Location:	6501 Shattuck Avenue- See map on reverse
Assessor's Parcel Number:	016 142801102
Proposal:	Two Appeals of the Zoning Manager's Approvals: 1) to construct a 4-story mixed-use building with commercial space and parking on the ground floor and 18 residential units above; and 2) for two additional required permits for a Multifamily Dwelling Residential Facility and more than 20% of the required group open space on the roof which were not included on the previous public notice or original Decision Letter.
Applicant:	Moshe Dinar (510)759-2133
Owner:	Bruder, LLC
Appellant:	Appellant 1) Chris Hall Appellant 2) Caitlin Stuart
Case File Number:	APL19003 and APL20010
Original Case File Number:	CDV10185
Planning Permits Required:	Interim Conditional Use Permit for a density of 18 residential units where the General Plan allows for 31 units and the zoning only allows for 5 units; Minor Conditional Use Permit for a Multifamily Dwelling Residential Facility and parking to be setback less than 75 feet from the front property line, Regular Design Review for new construction; and Minor Variances to allow a 13-foot high garage podium structure to project 7 feet into the required 15-foot rea

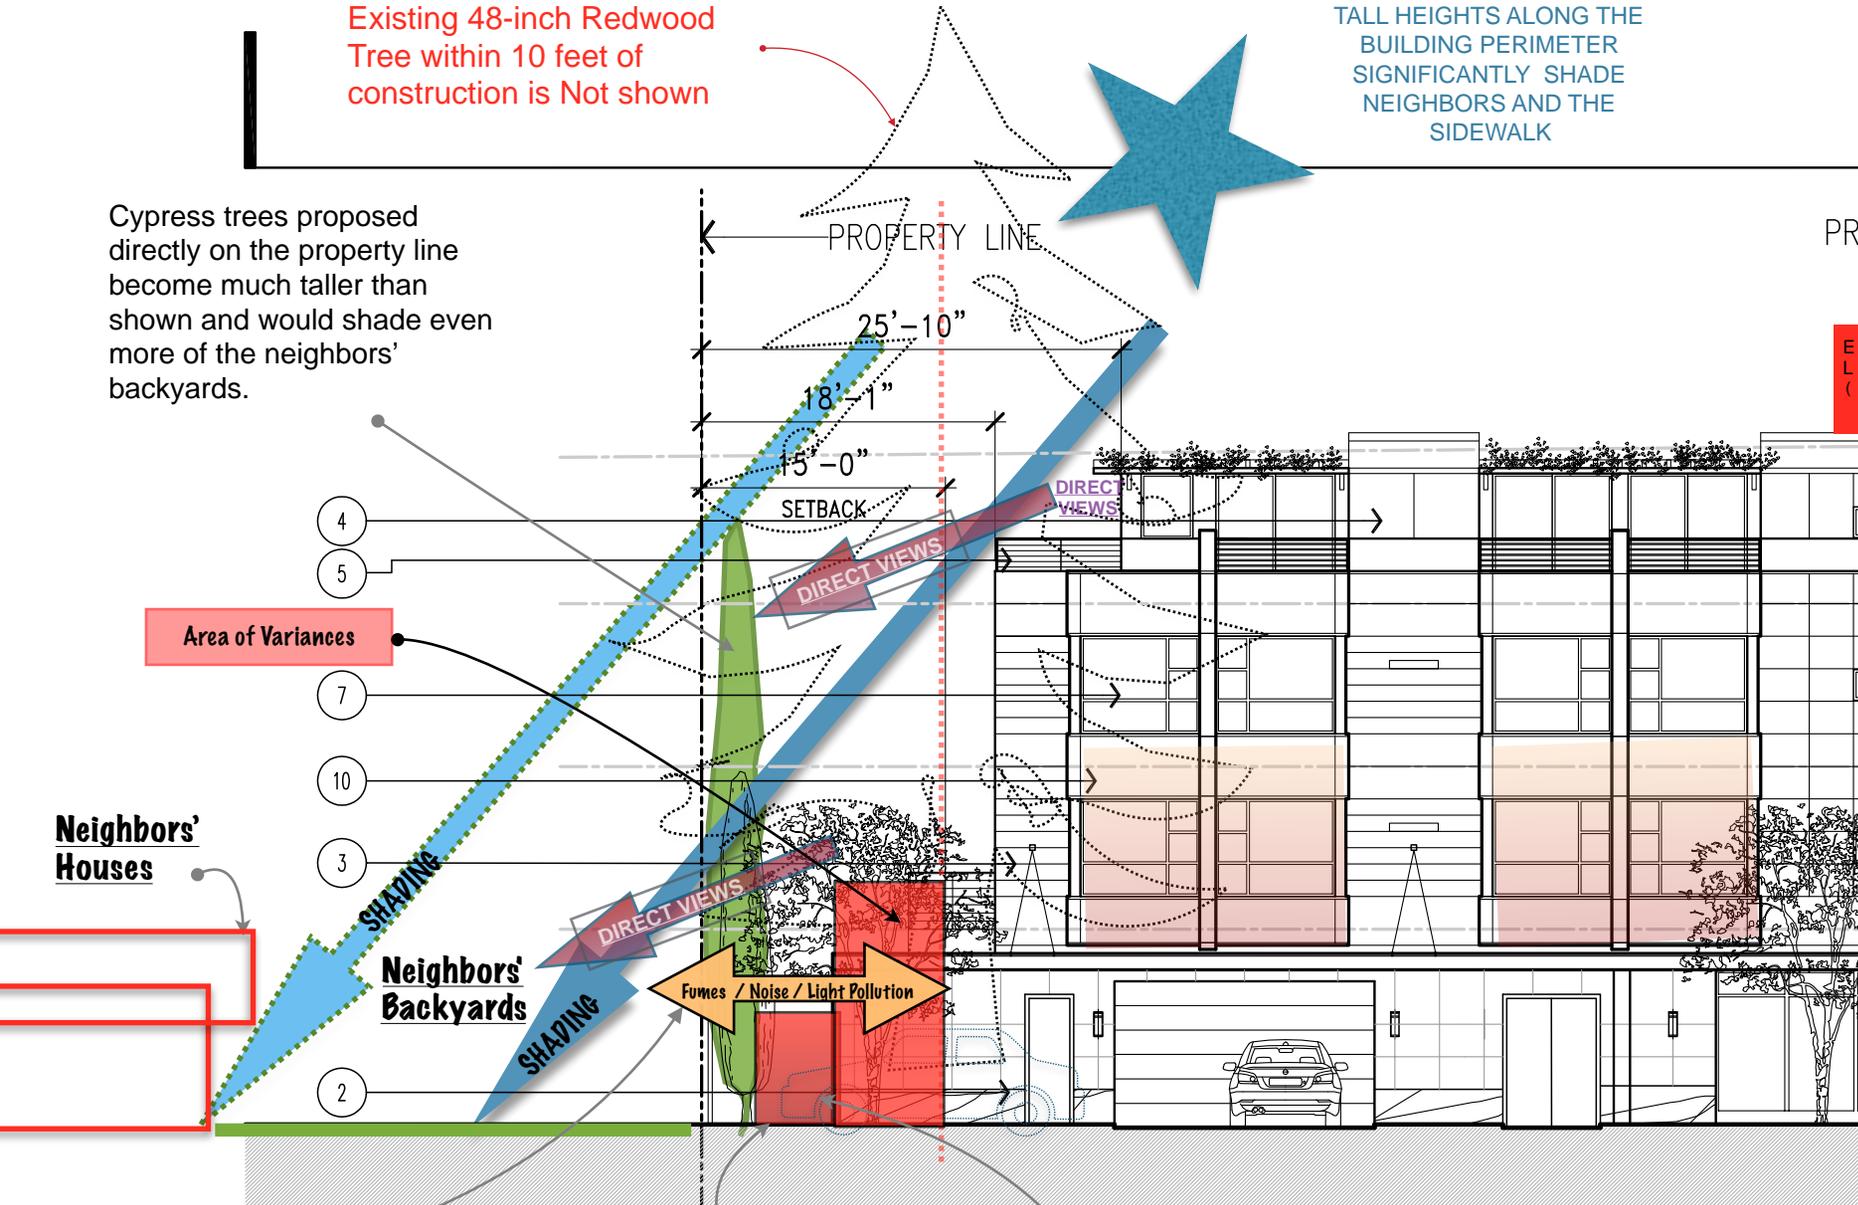
TALL HEIGHTS ALONG THE BUILDING PERIMETER SIGNIFICANTLY SHADE NEIGHBORS AND THE SIDEWALK

Cypress trees proposed directly on the property line become much taller than shown and would shade even more of the neighbors' backyards.

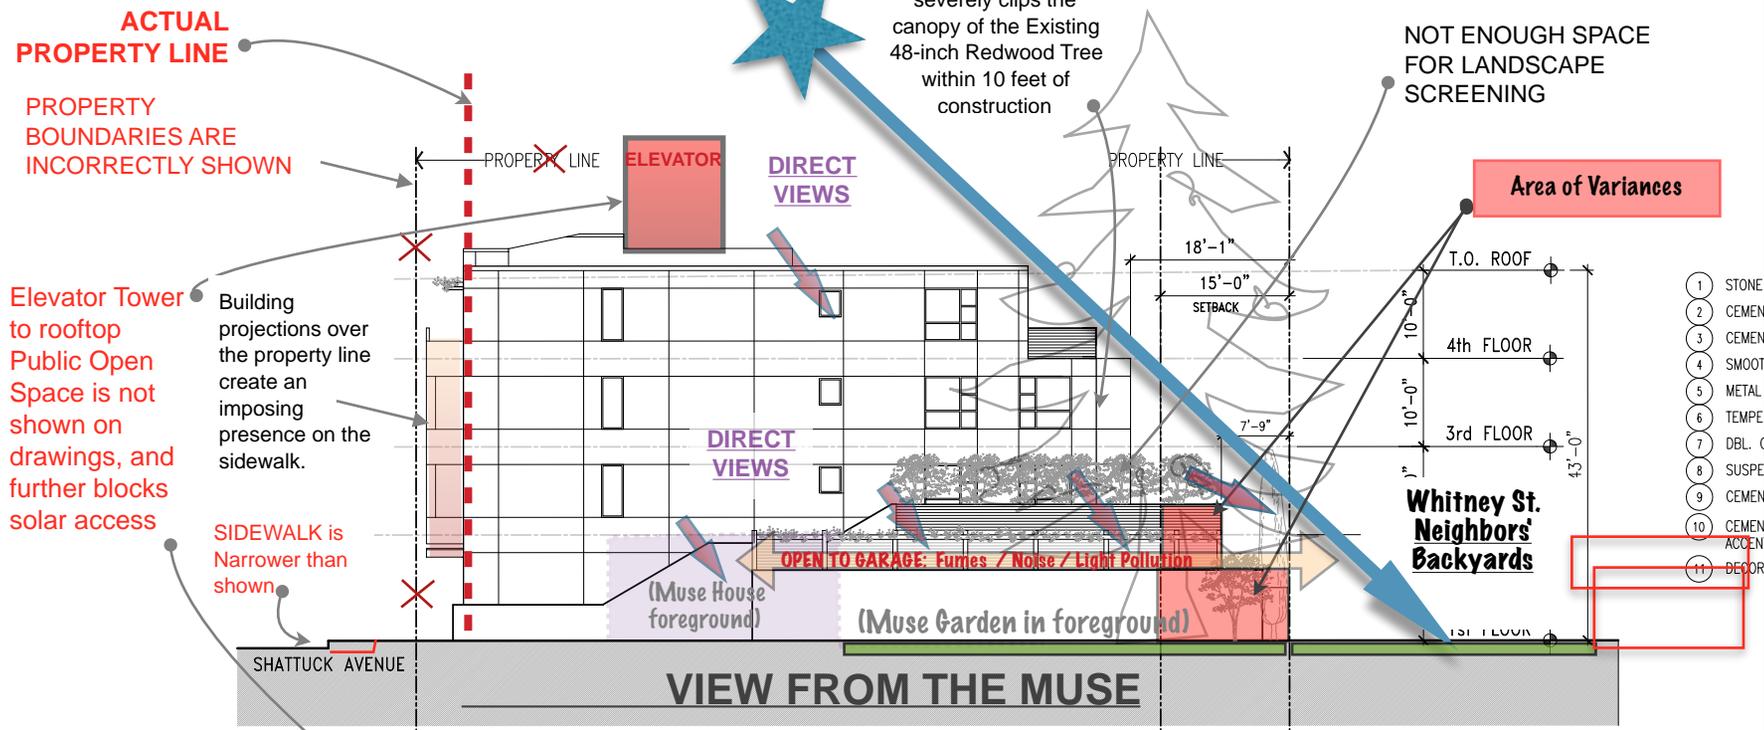
Proposed Six-foot tall CMU Wall encroaching into setback are not shown on the elevations

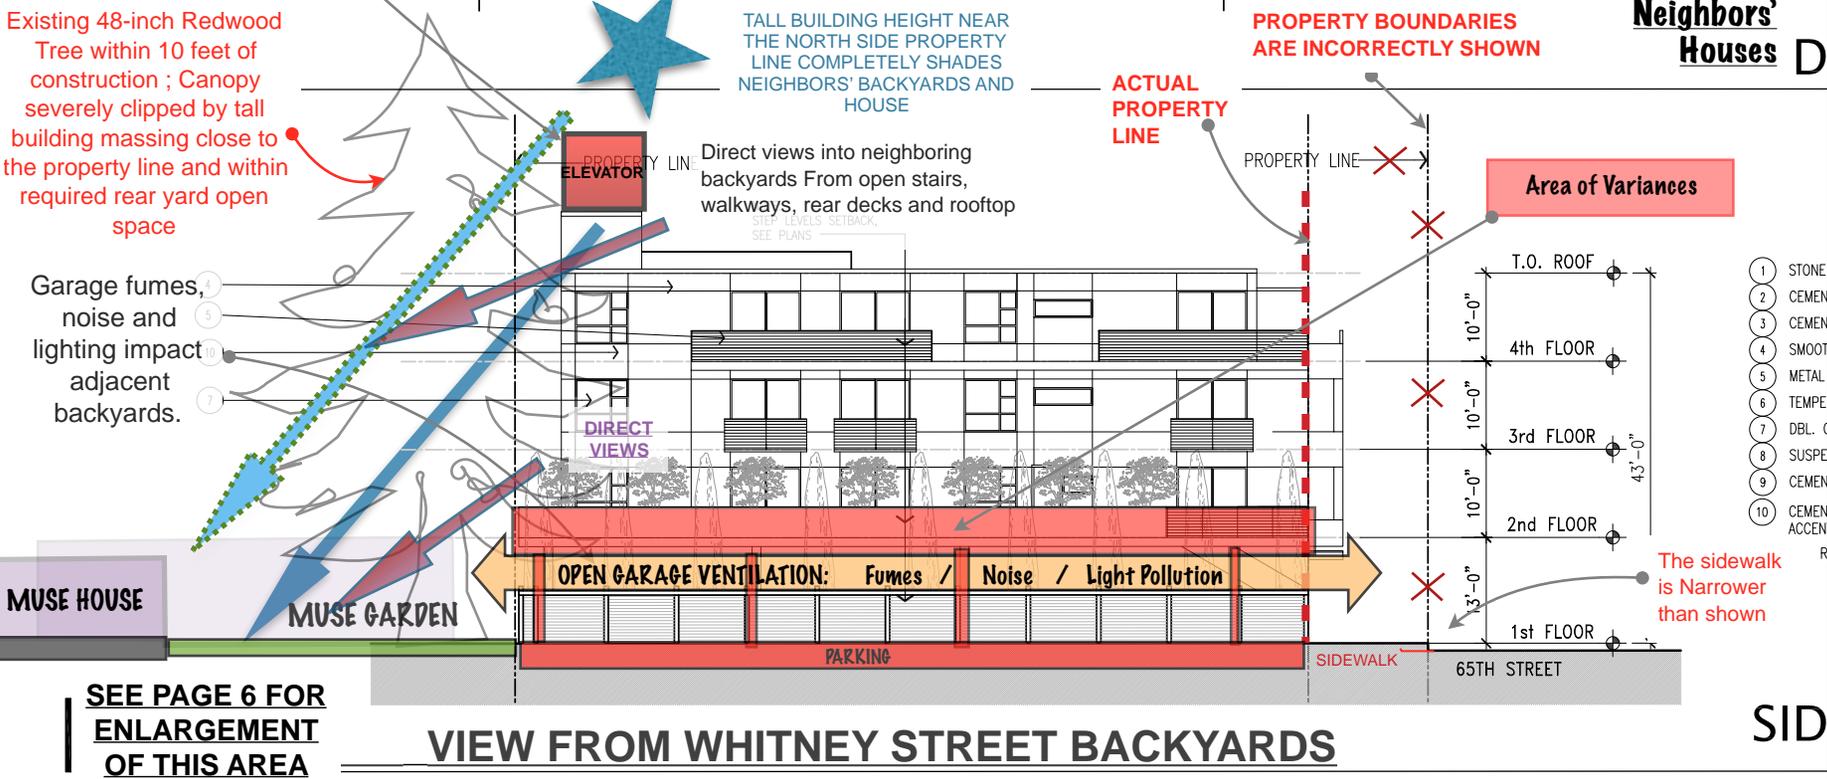
Cars encroach into required setbacks, leaving no room for landscaping

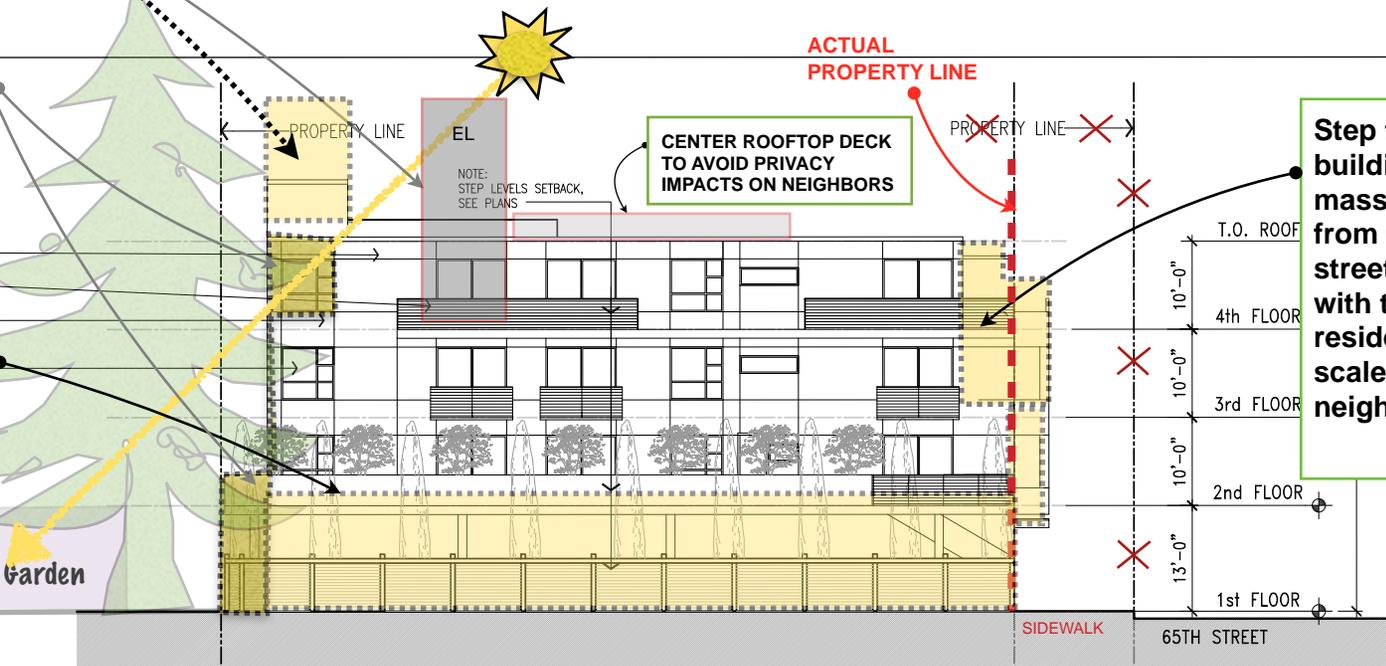
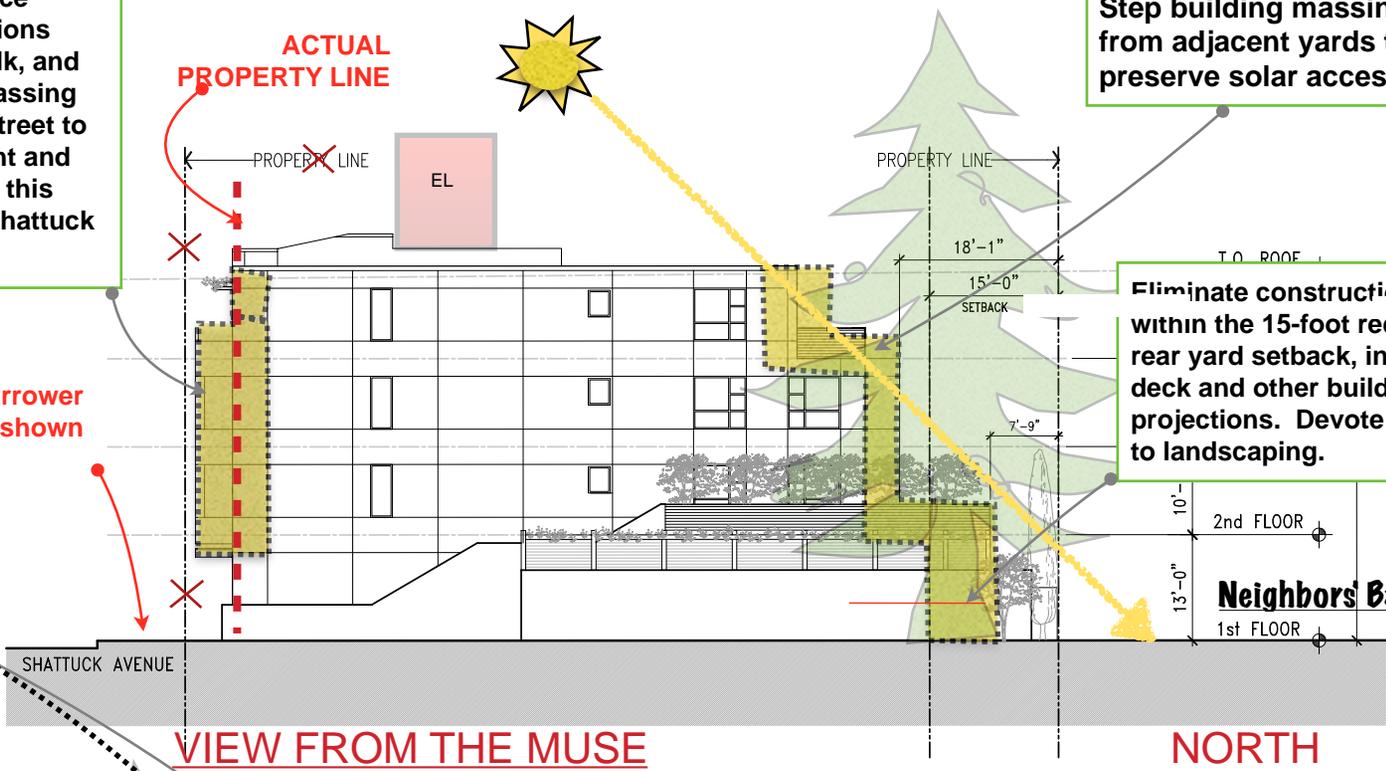
Step building massing away from north side property line and eliminate open stairs and elevated walkways directly on the property line

Relocate the group open space to the roof, and use parking lifts to eliminate paving in the rear yard setback. Dedicate the space to landscaping and at-grade open space

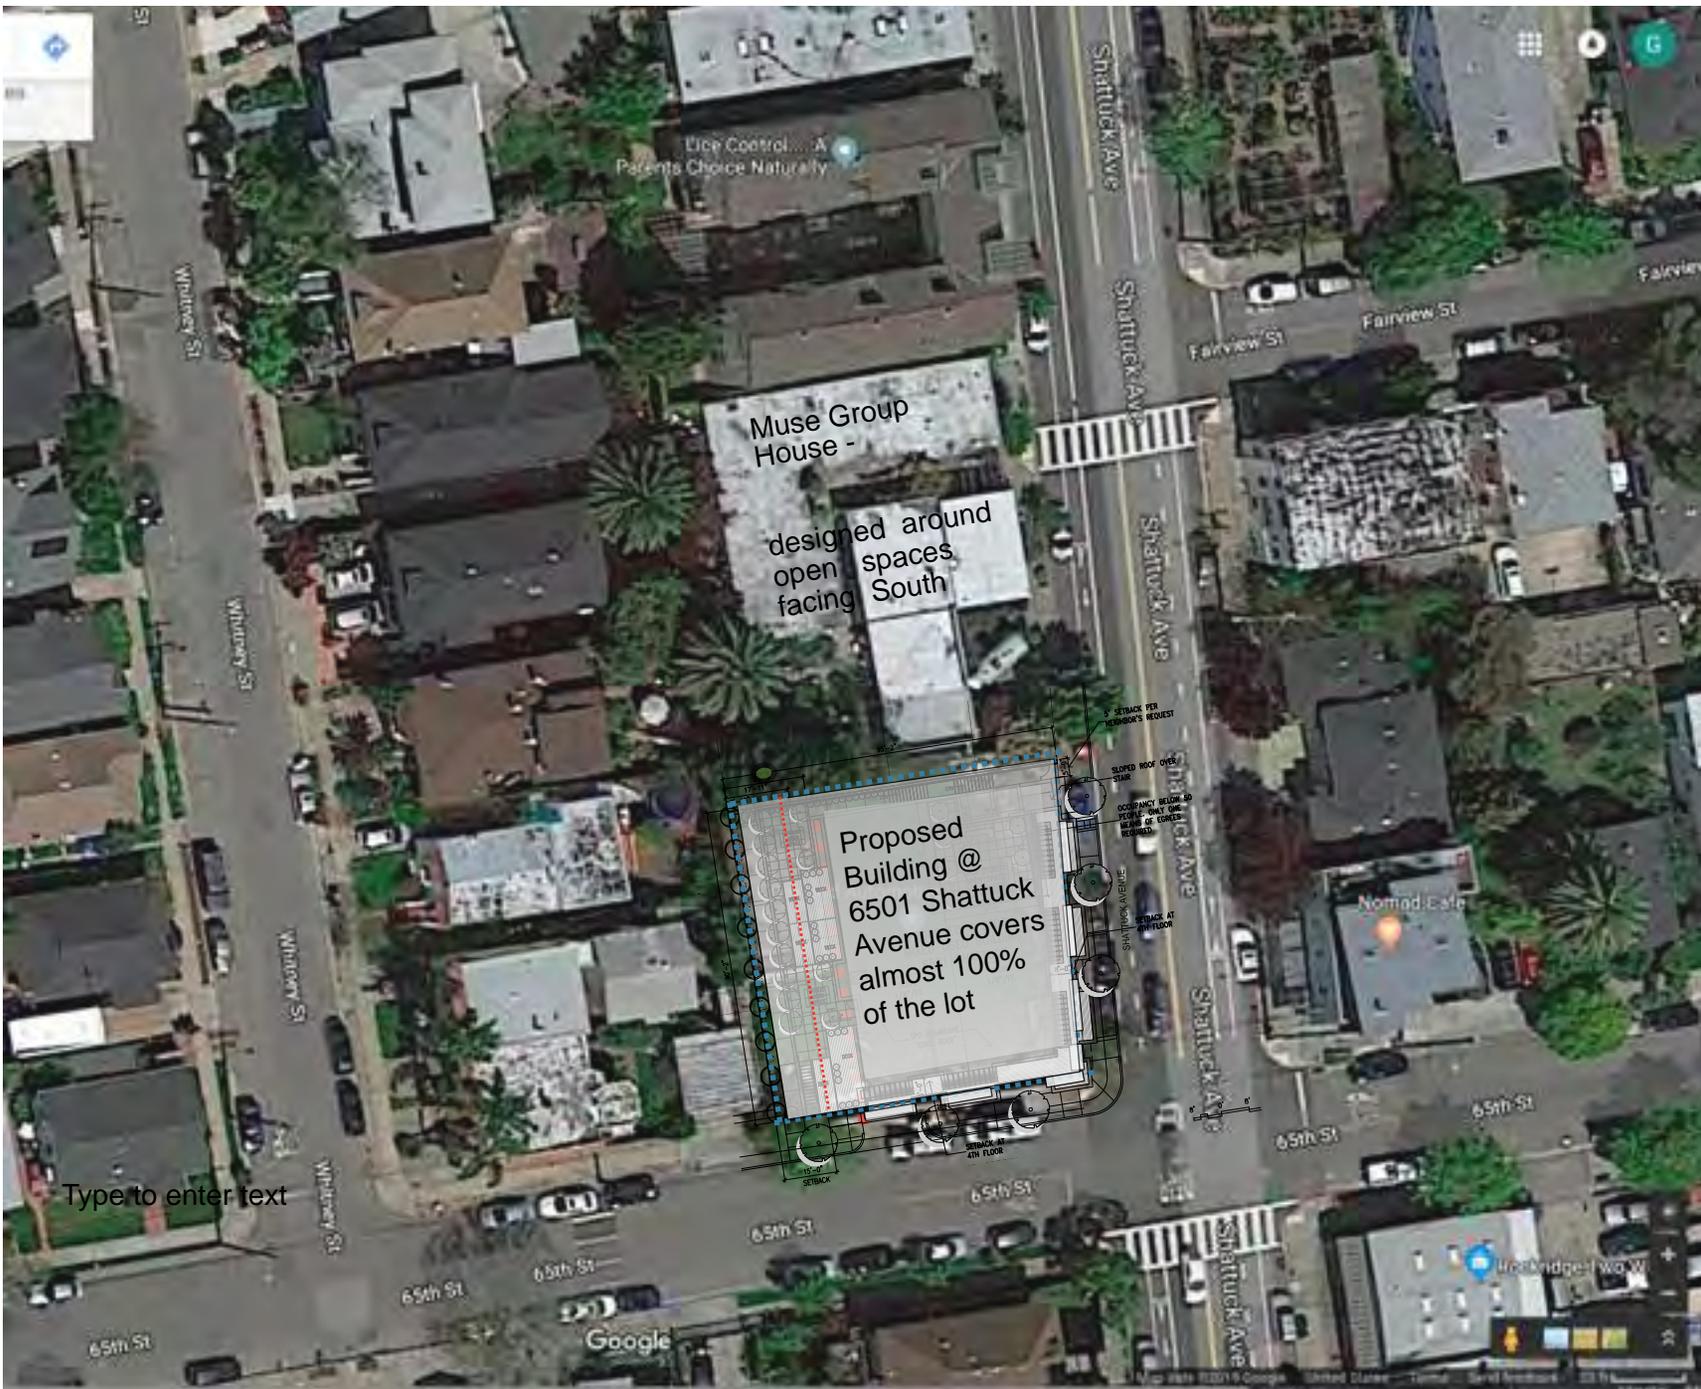
MAIN ISSUES

- The lot will be completely covered by building.
- Complete shading of adjacent buildings and rear yards
- Privacy and noise impacts from elevated structures and open spaces directly on property lines
